**LEBANON PLANNING BOARD
DECEMBER 9, 2024 - 6:30 PM
COUNCIL CHAMBERS, CITY HALL OR
REMOTE VIA VIRTUAL PLATFORM
LEBANONNH.GOV/LIVE**

Staff Memorandum – PB2024-22-SPRCUP – *con't from 11/12/24*

Site Plan Review and CUP for a proposed 474-unit multi-family PURD, and a CUP to allow an increase in the maximum permitted building height from 45 ft. to 55 ft.

- ▶ Plan set titled “The Brickyard Residential Development,” dated May 10, 2024, latest issue December 4, 2024, prepared by VHB, EV Project: 52933.00 (53 sheets plus cover sheet)

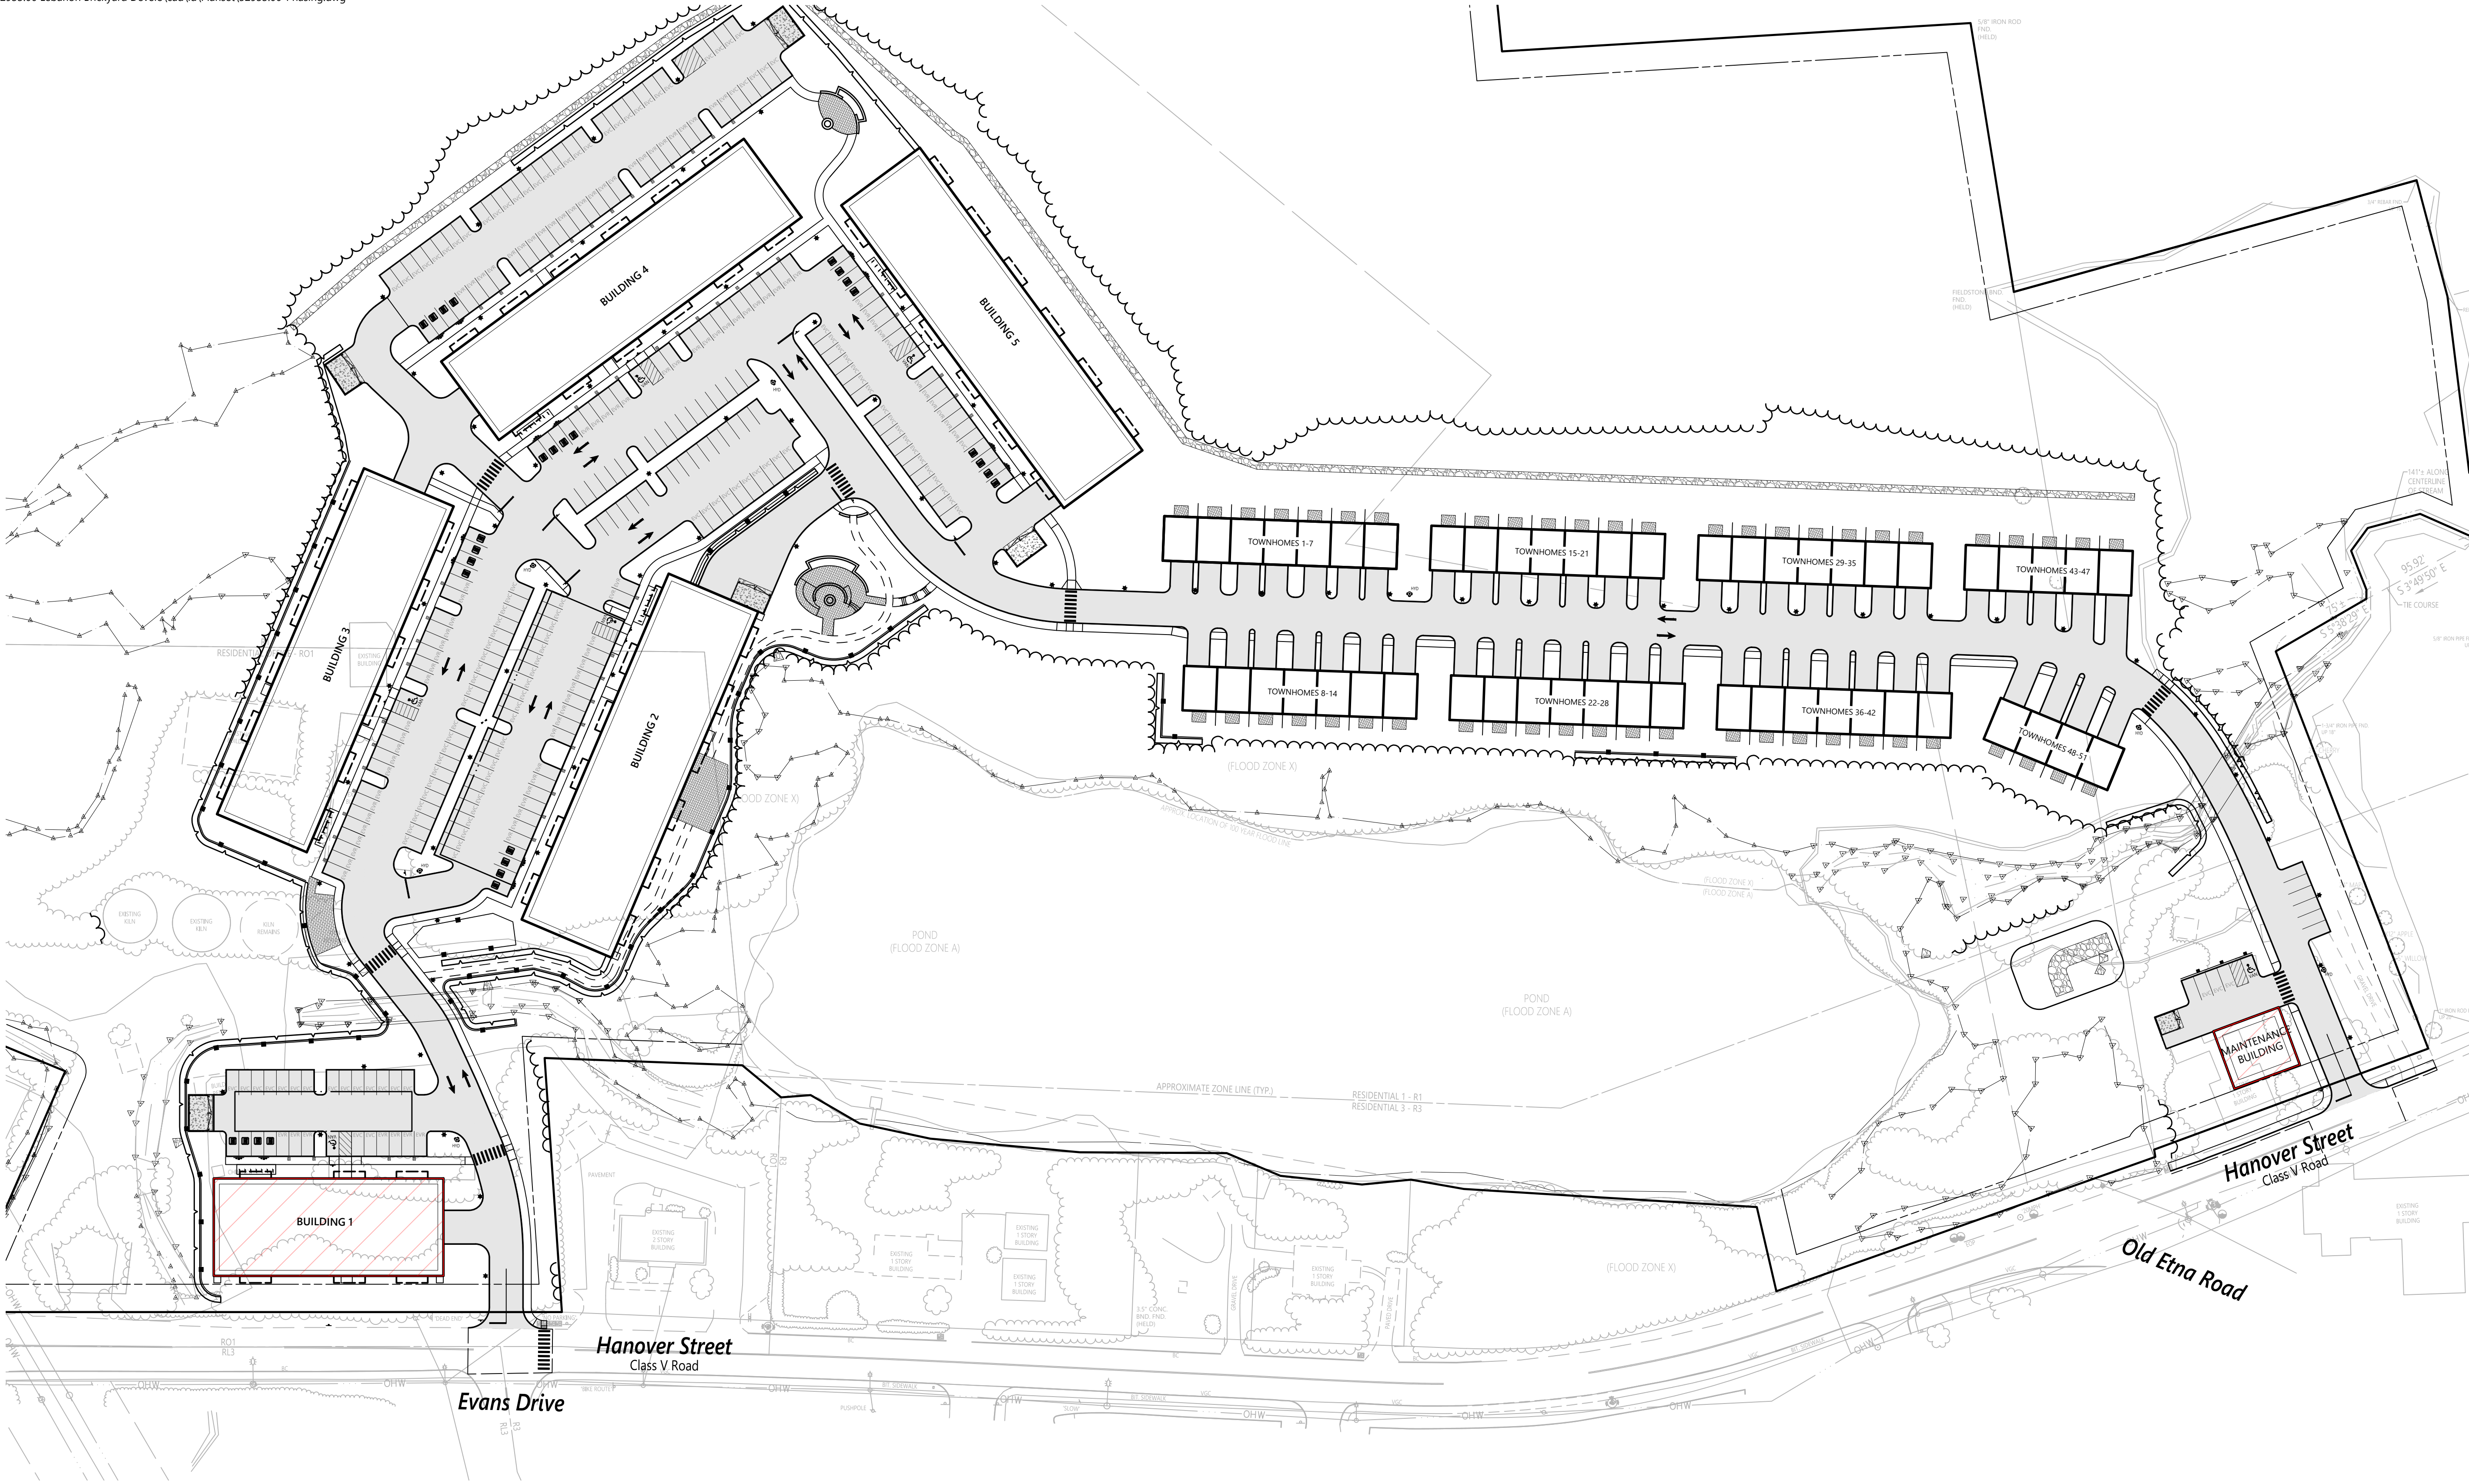
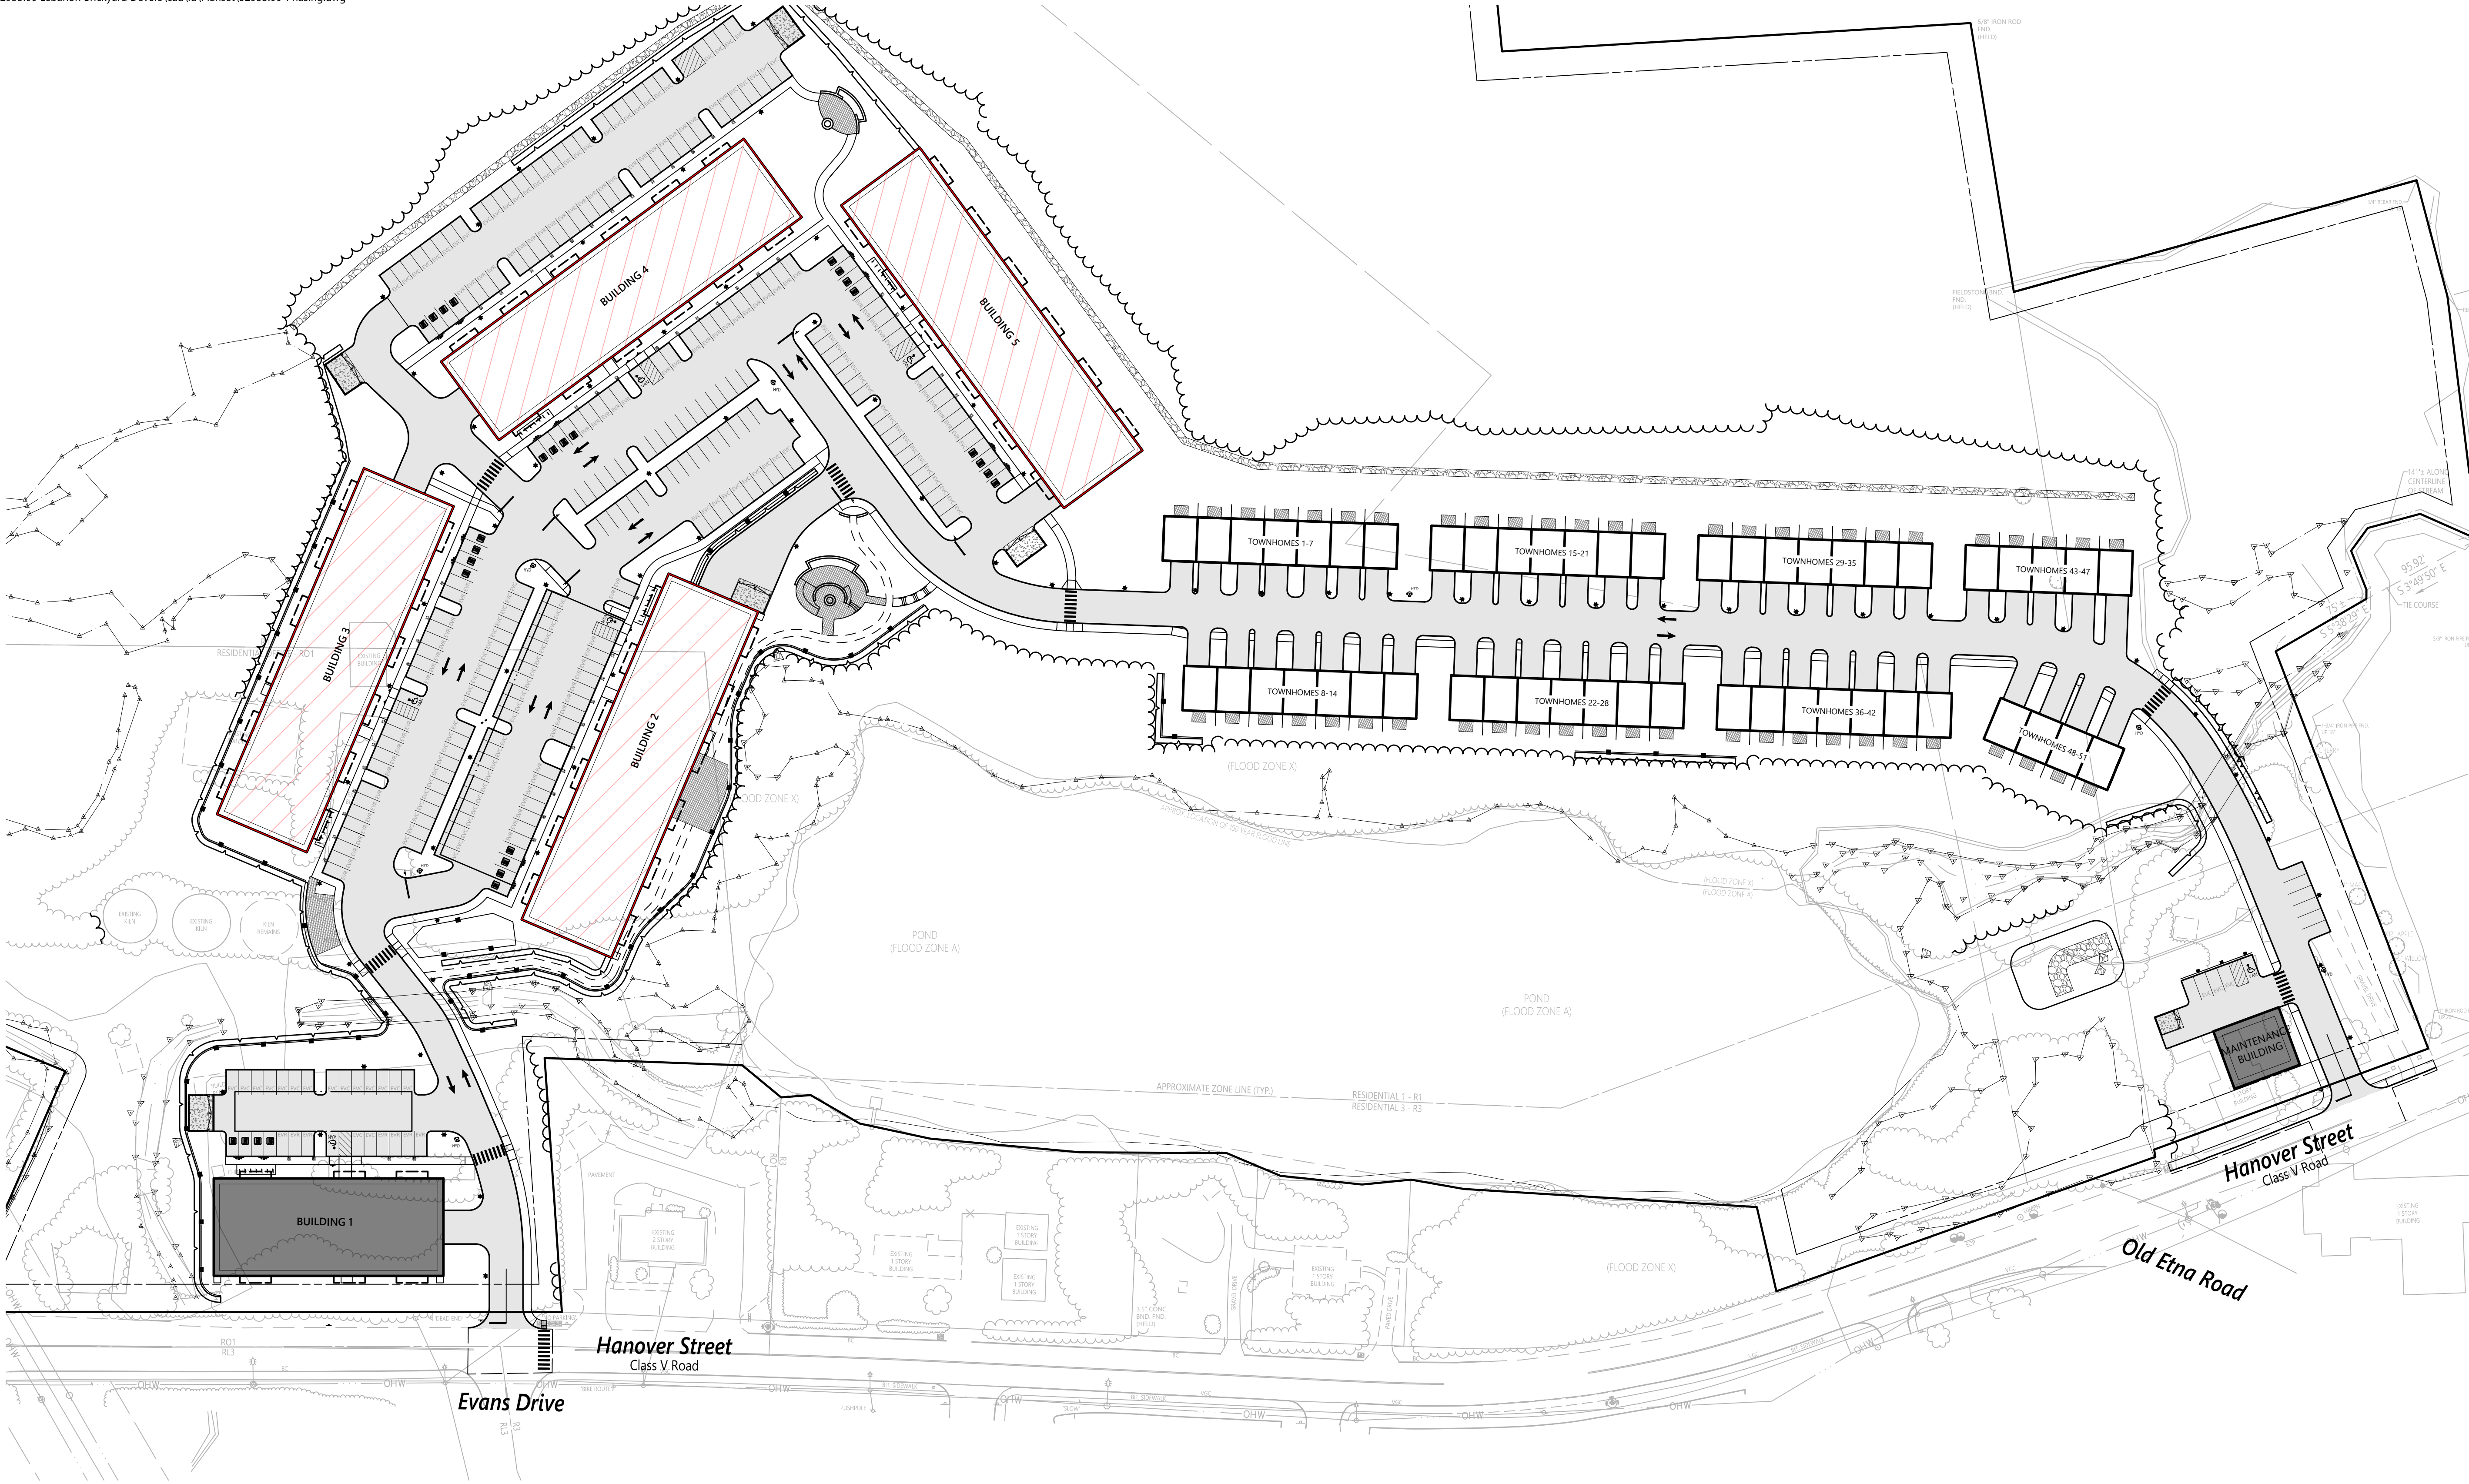
19. Phasing Plan - Sheets 30-33 (C8.1-4)

21
22 Mr. Ford Burley said he noted that (per C8.1 of the Phasing Plan) the townhouses will be built
23 after Phase II, but Buildings B, C, and D will be built based on occupancy and market. He asked if
24 the applicant could provide a commitment to build those townhouses regardless of the market for
25 studio apartments and one-bedroom units. He asked if they have explored whether the townhouses
26 could be made into condominiums. Mr. Fenstermacher said they did look at it, but he thought they
27 would have to have subdivision approval to do that. Mr. Corwin said there may be another way
28 and Mr. Fenstermacher said they will continue to work with Staff to try to accomplish it.
